GOVERNMENT OF INDIA  
MINISTRY OF ENVIRONMENT & FORESTS  
**Central Zoo Authority**

F. No. 19-114/92-CZA(271)(Vol. IV)(M)/5147

**Sub: Proposed designs for the construction of Tiger and Red panda exhibits at Pt. G. B. Pant High Altitude Zoo, Nainital.**

A PLAN SHOWING THE PROPOSED ENCLOSURE AND NIGHT SHELTER FOR RED PANDA AT HIGH ALTITUDE ZOO NAINITAL (SCALE- 1:200)

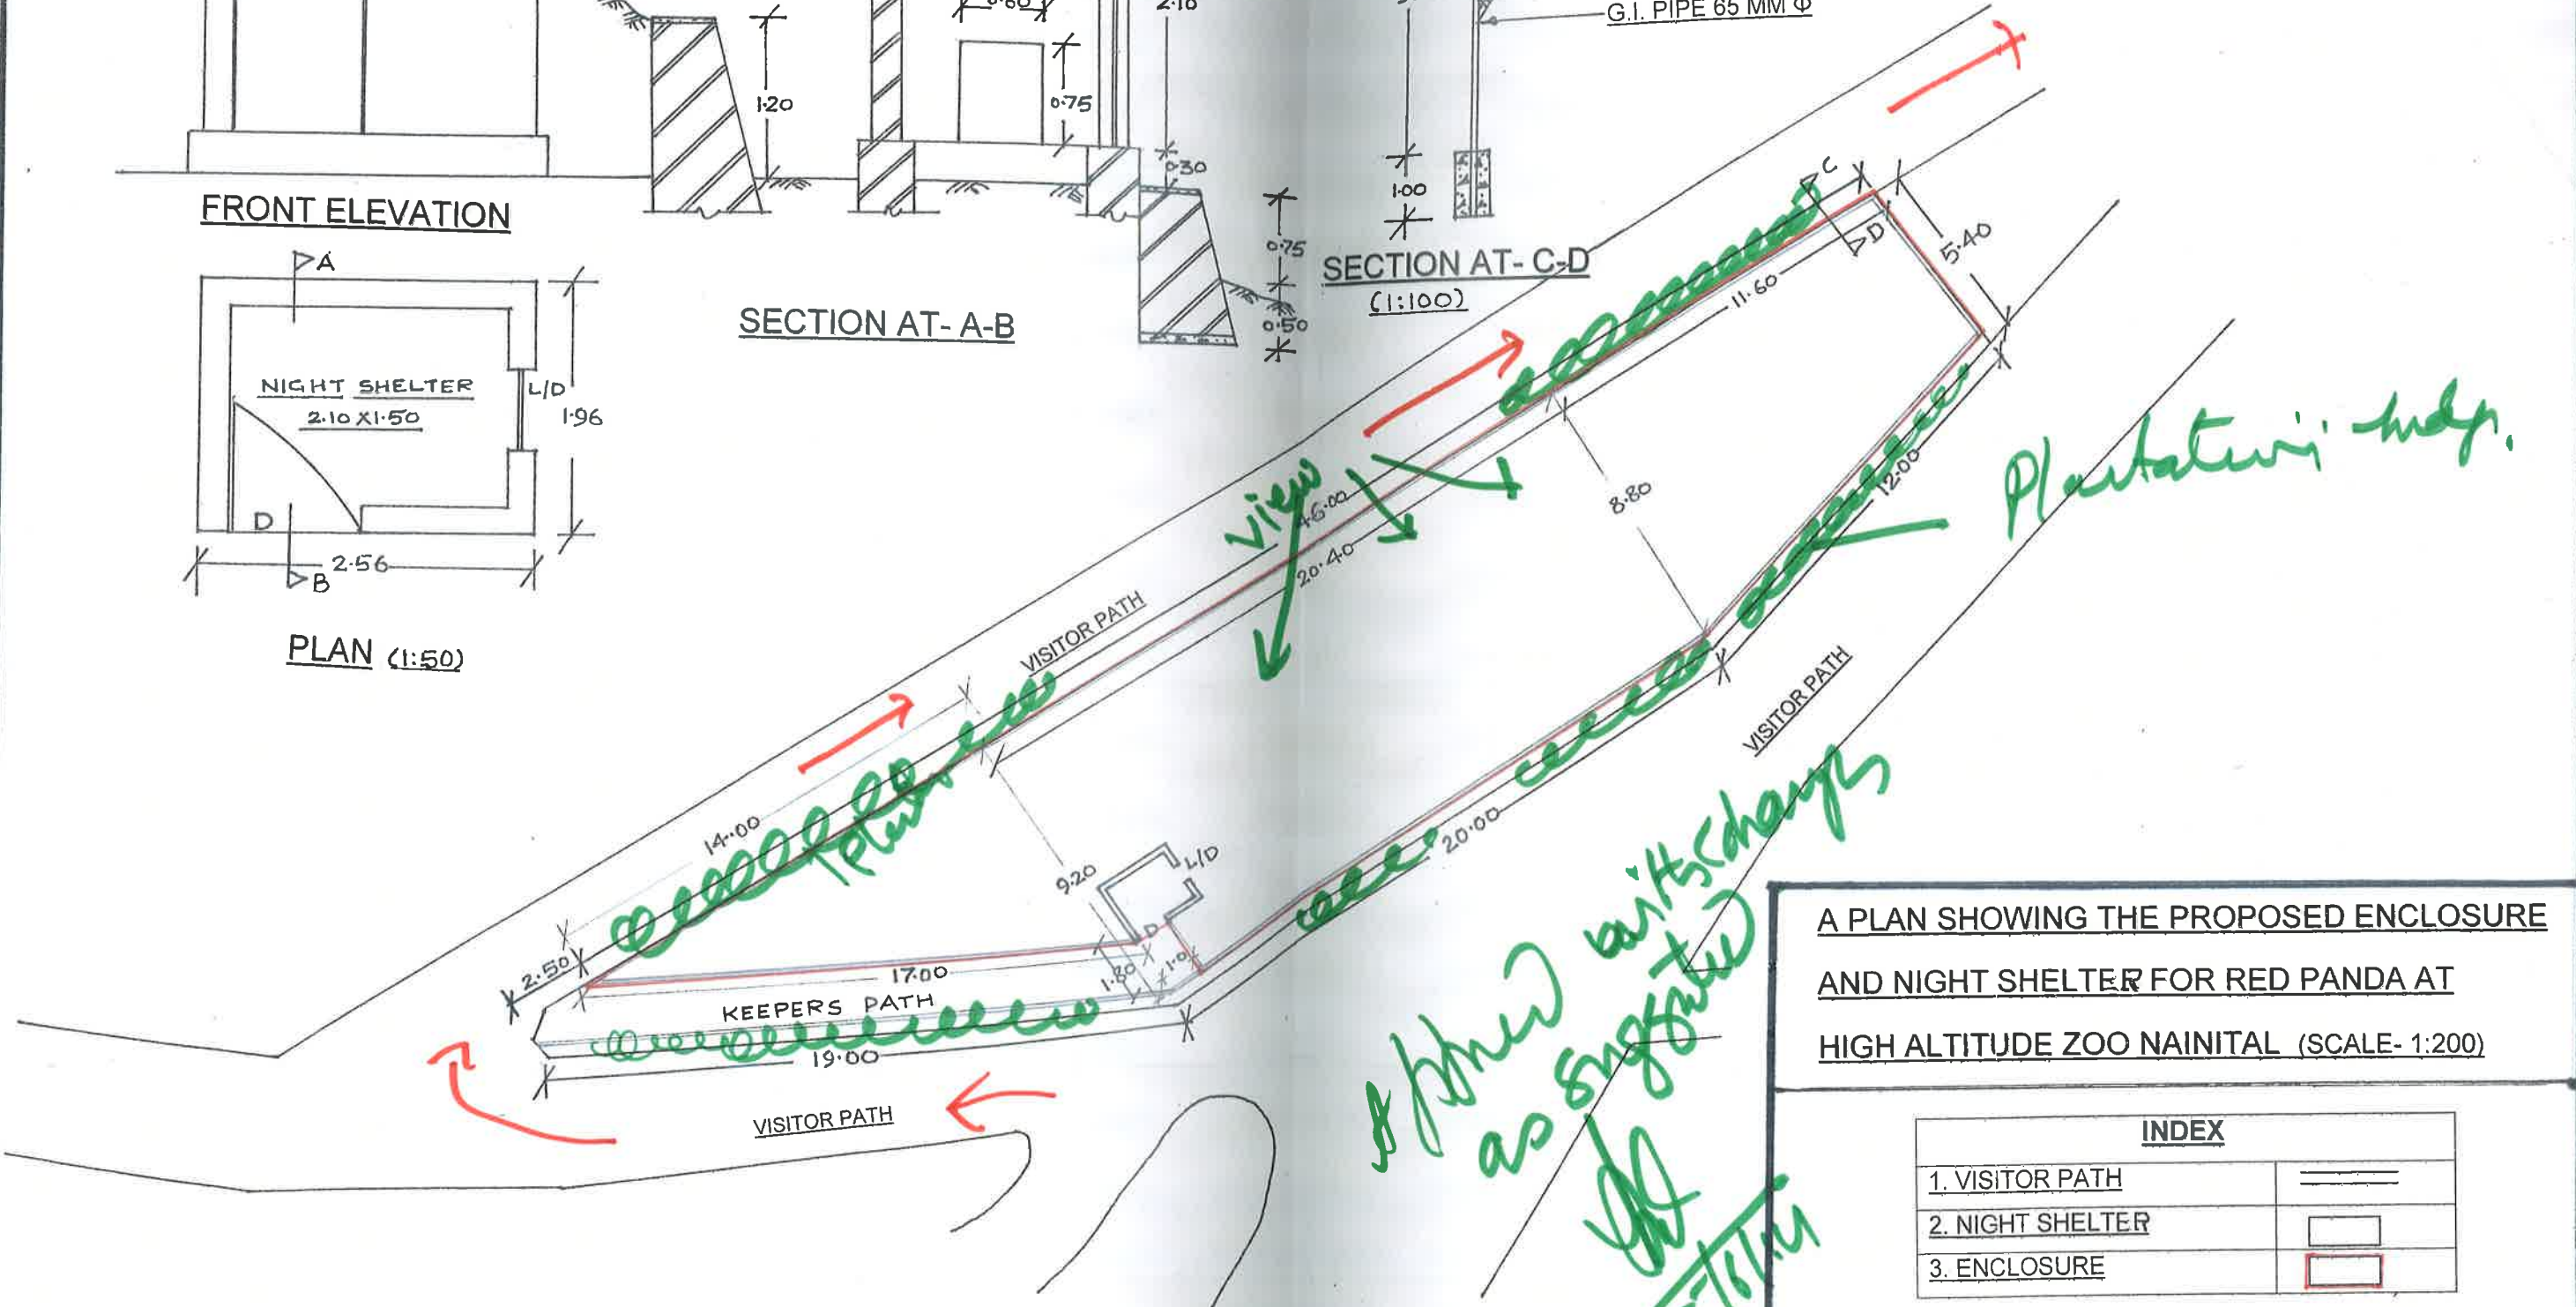
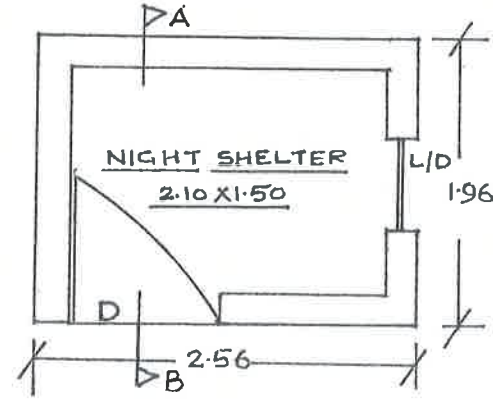
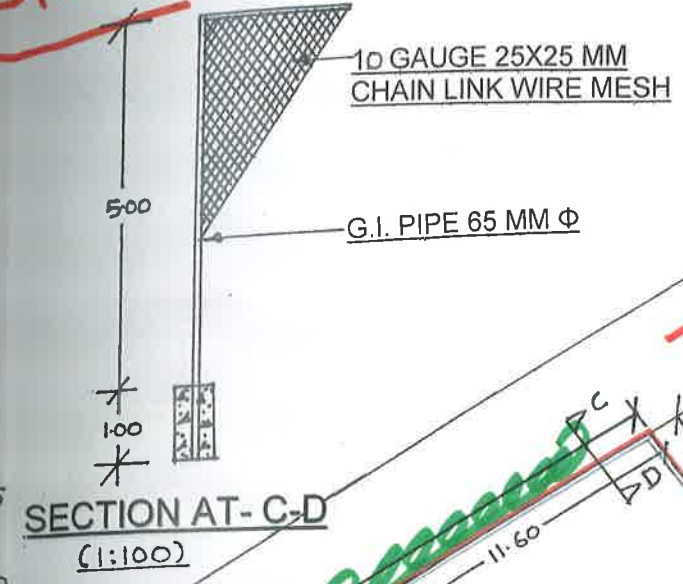
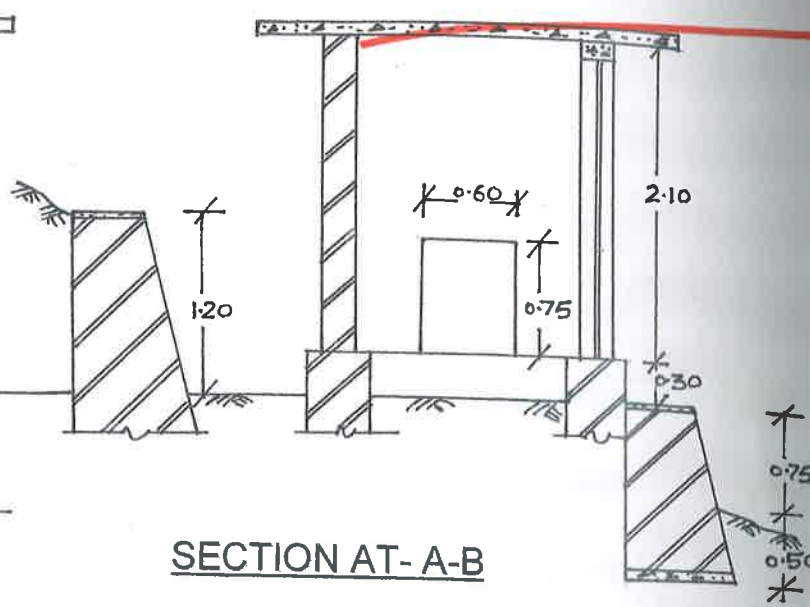
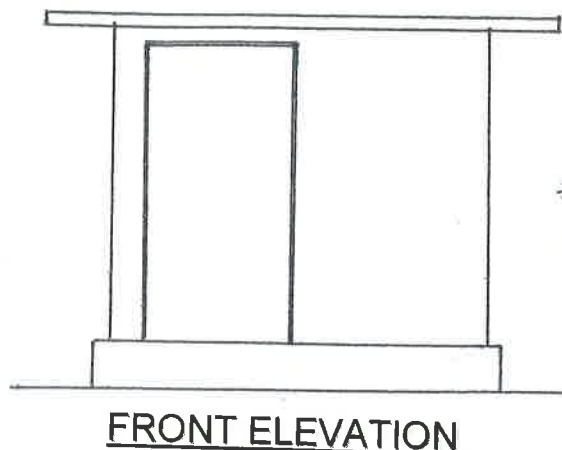
The design was approved as recommended by Sh. A. K. Jha, Director, Padmaja Naidu Himalayan Zoological Park, Darjeeling as per decision of the Technical Committee and Expert Group on zoo Designing and the recommendation received from Sh. A. K. Jha on the assessment of the proposed Red panda enclosure during the inspection of Nainital Zoo on 13<sup>th</sup> March, 2014. The area is gentle slope, with two

large trees on it. There is a chain-link fencing, on iron angles. The area is recommended for Red panda enclosure, as it can be manipulated by way of providing bamboo plantation, cubbing boxes, furniture (aerial walkways) as enrichment and a water flow if possible. The chain-link can be removed and 5-6 high carbonated transparent fiber glass sheet can be used on iron angles to cover the enclosure. The area being sunny is added advantage.
